**CITY OF ROSEBURG
HISTORIC RESOURCE REVIEW COMMISSION
Wednesday, July 17, 2024
Roseburg City Hall, Council Chambers – 4:00 p.m.**

CITY OF ROSEBURG HISTORIC RESOURCE REVIEW COMMISSION AGENDA ITEM REPORT

HRRC Review No. HR-24-013**Meeting Date: Jul. 17, 2024**

Prepared for: Historic Resource Review Commission
Staff Contact: Mark Moffett, Senior Planner
Request: Historic Review Alteration Request at 338 SE Jackson Street.

SOUTH ELEVATION

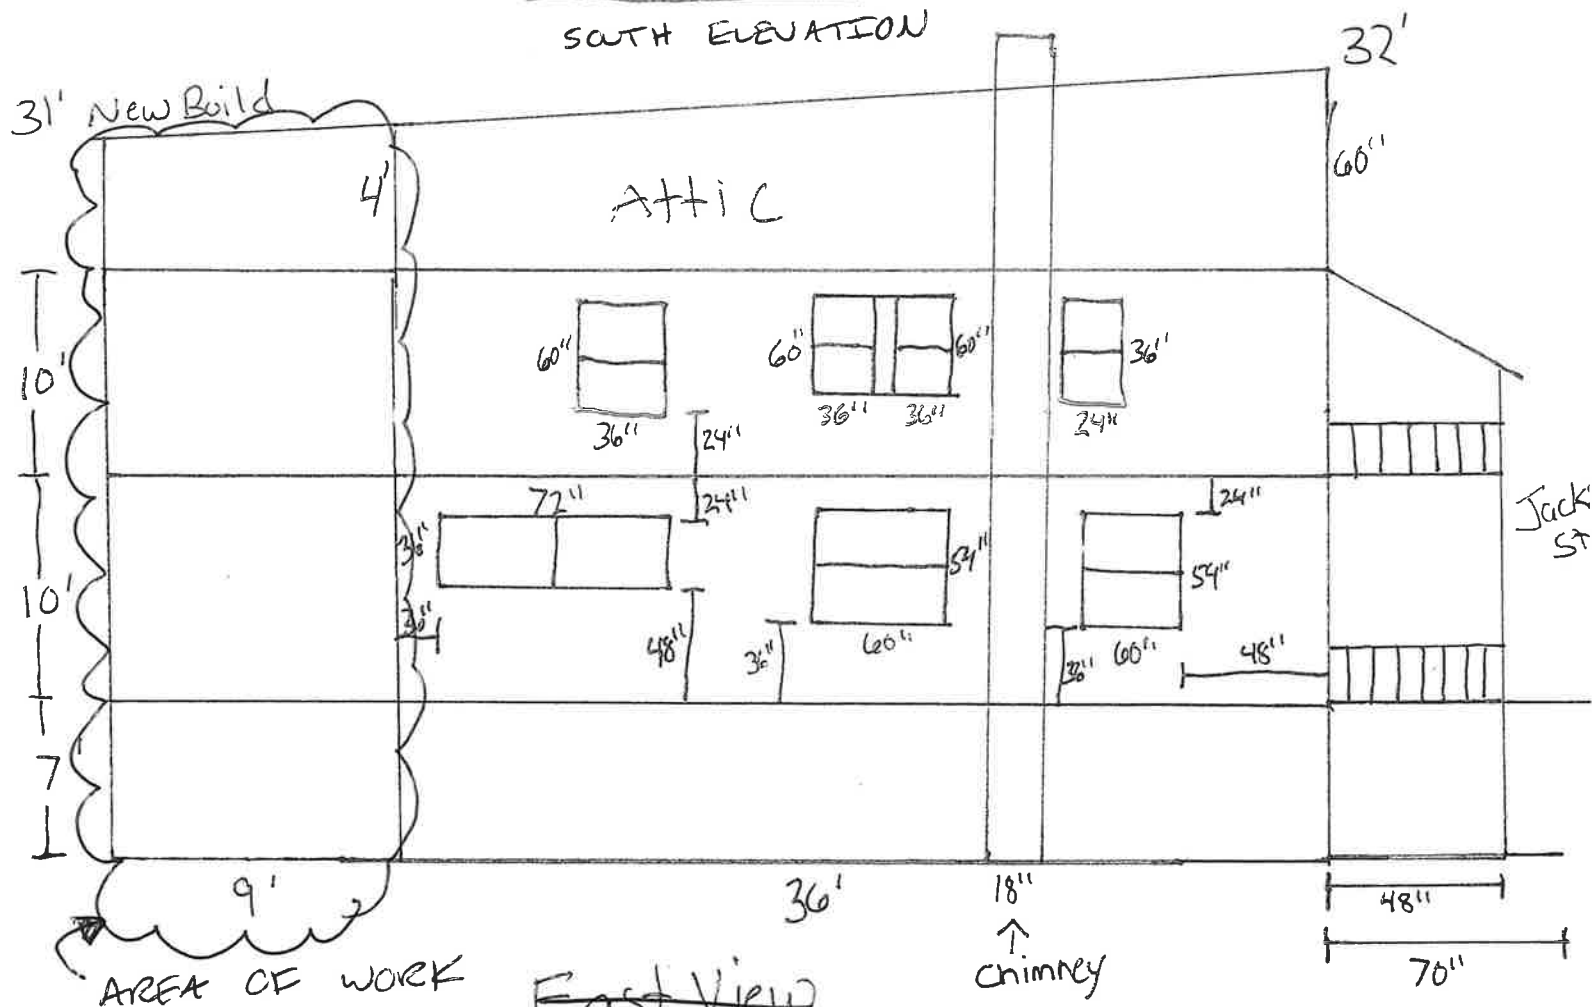
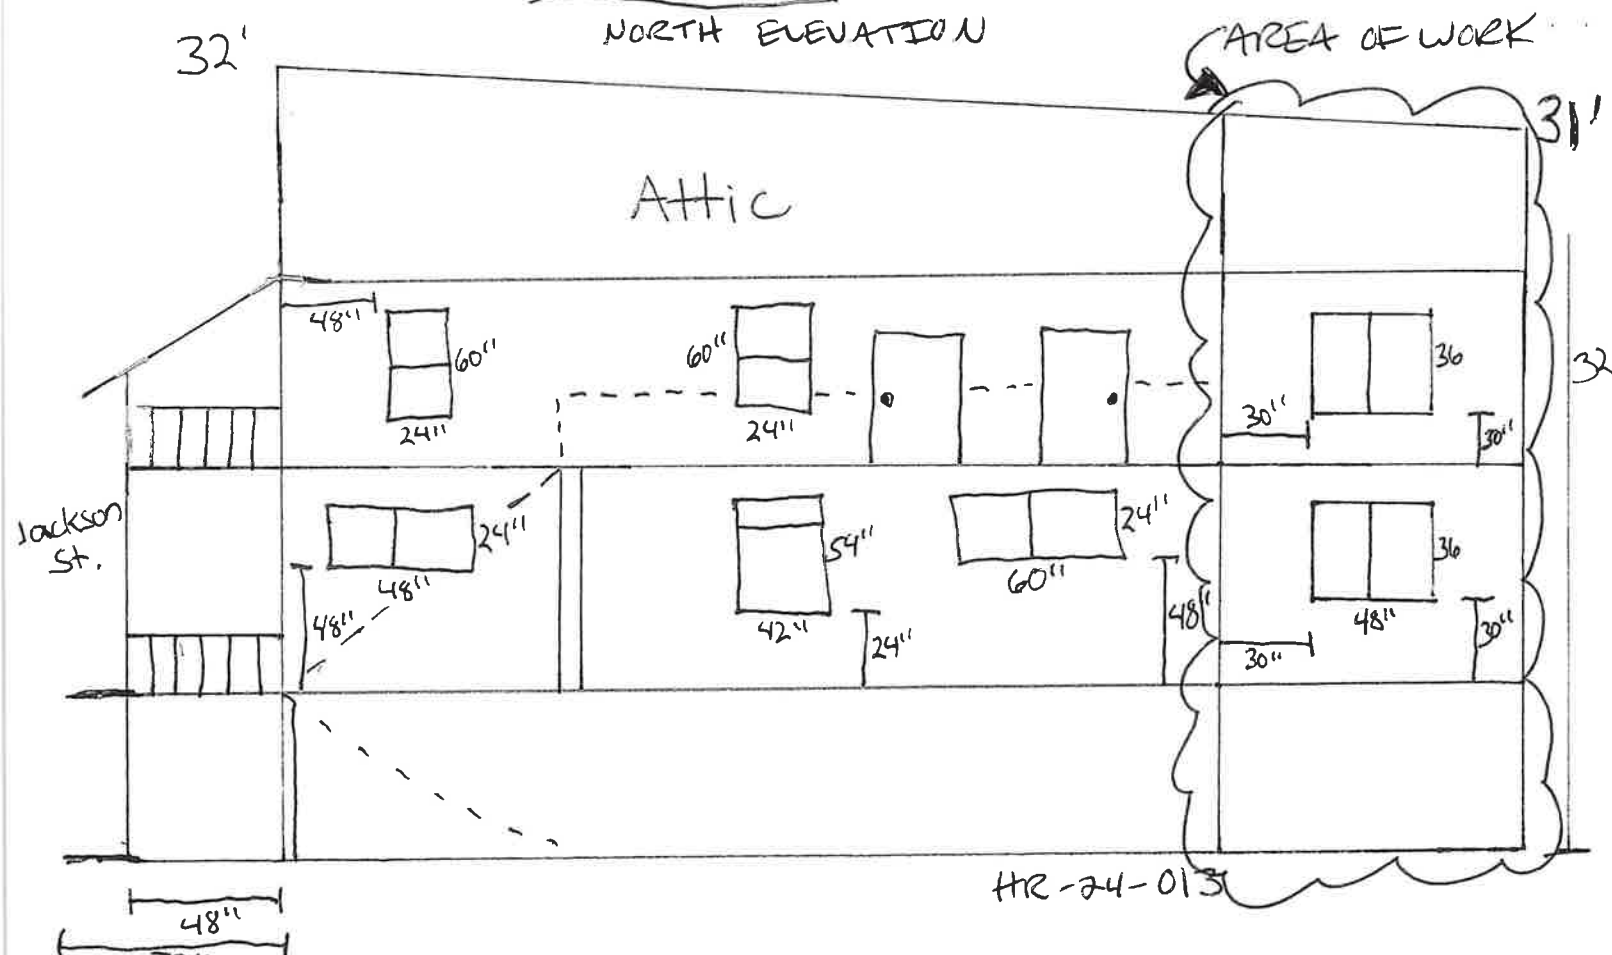
Findings for 1: The original second-story screen porch on the back of the building was removed and replaced with newer balloon-frame wood construction, some new exterior vinyl windows, and also some exterior plywood sheathing around part of the new construction (see photos in section B, above). Enclosing exterior space underneath the existing roof is in keeping with the original general massing of the building, but aside from the prior screen porch walls and screen window openings there are no impacts to the original construction. Although it is unfortunate that this prior historic

material was removed, it has been destroyed by the owner/applicant and is no longer available to be restored in place. Because it is no longer possible to preserve the original screen porch, this criterion is met.

Back View

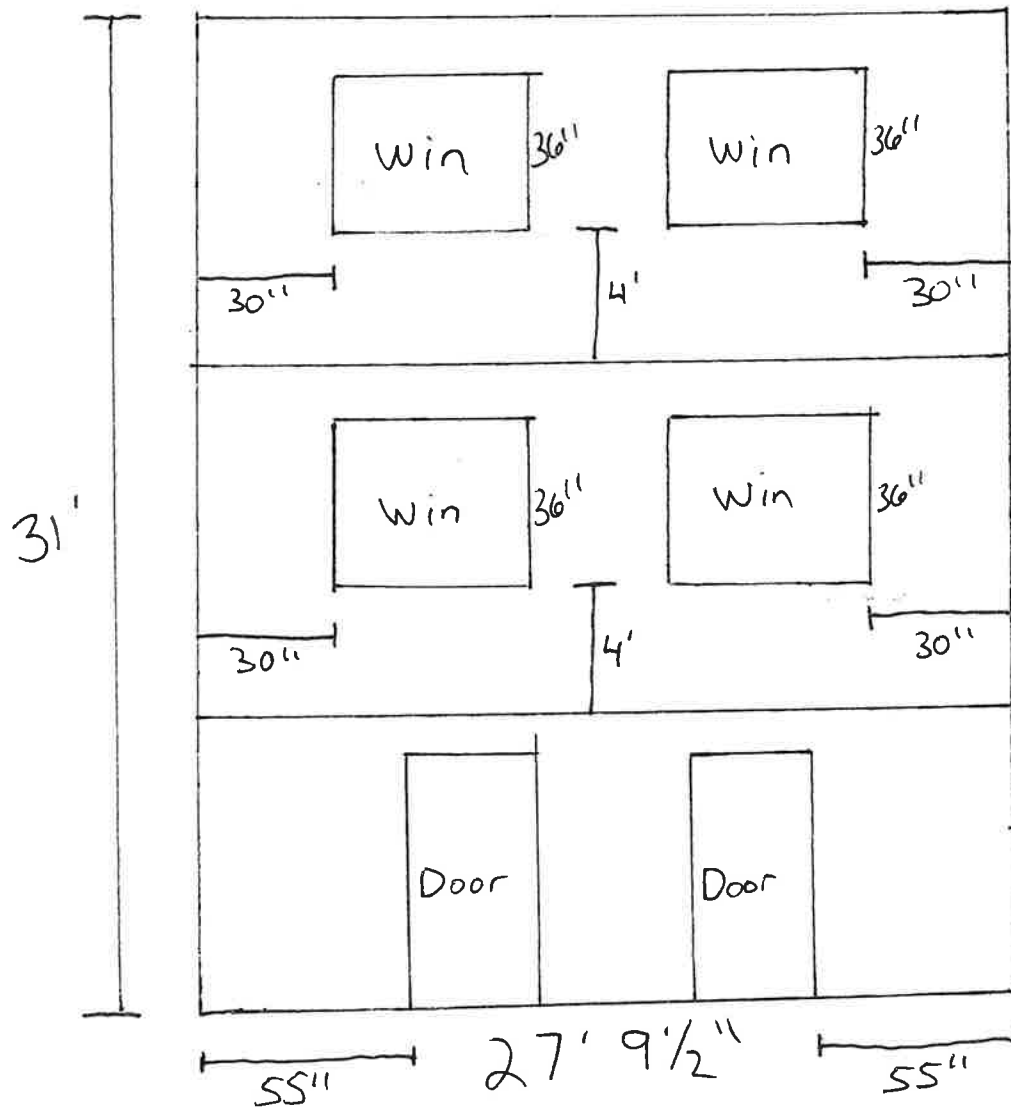
Findings: The proposed additions at the rear of the building fall underneath the footprint of the original historic roof structure, although the new enclosure of the lower two floors beneath the old screen porch are technically horizontal additions. As the new enclosed areas fall underneath the historic roofline, the additions do not exceed that which was traditional for this traditional, rectangular building style. The new enclosed area at the back of the building generally maintains the traditional scale and proportion of multi-story historic commercial building styles. By applying horizontal siding and a belly band on the upper most visually prominent floors that mimic the reveal and dimensions of the existing siding elsewhere on the building, the addition is visually compatible with the current building and others nearby. Therefore, based on the submitted drawings and materials details, this guideline is met.

Findings for 5 and 6: The window to wall relationship in the added building area at the rear of the building uses simple vertical door openings that are in keeping with the historic architectural character of the building. The new window openings are horizontal in orientation and proportion, whereas the existing structure includes primarily vertical window openings. However, there are large fixed horizontal window openings on each of the original side facades, so a horizontal window opening itself is not unprecedented on the building. The slider-type vinyl windows that are proposed are a significant design departure from the hung and fixed windows on the intact historic openings of the building, and the thinner sash design is a departure from the wood windows and doors found

elsewhere, which feature thicker sashes and muntins than are proposed with the addition. However, the rear of the building originally featured a screen porch with thin-framed screen windows. Applying compatible trim, siding and a matching belly band between the basement and first floor will help increase the visual compatibility of the addition. Although the new windows themselves are not ideal in this regard, and will stick out visually to the keen observer, these features are already in place and the rear portion of the building occupies secondary facades that are not immediately visible from the street, but mostly only from the alley. This guideline is met.

- All windows new white
10' Vinyl Sliders

- 2 36" wide doors for basement access

- Matching horizontal siding on new build 1st + 2nd floor

- Bottom area will have same vertical 1"x3" cedar

- 10" separation between 1st Floor and basement level using 1x10 cedar

- Siding is 8" hardy plank matching existing

- All windows will be trimmed out with 1"x6" cedar to match existing
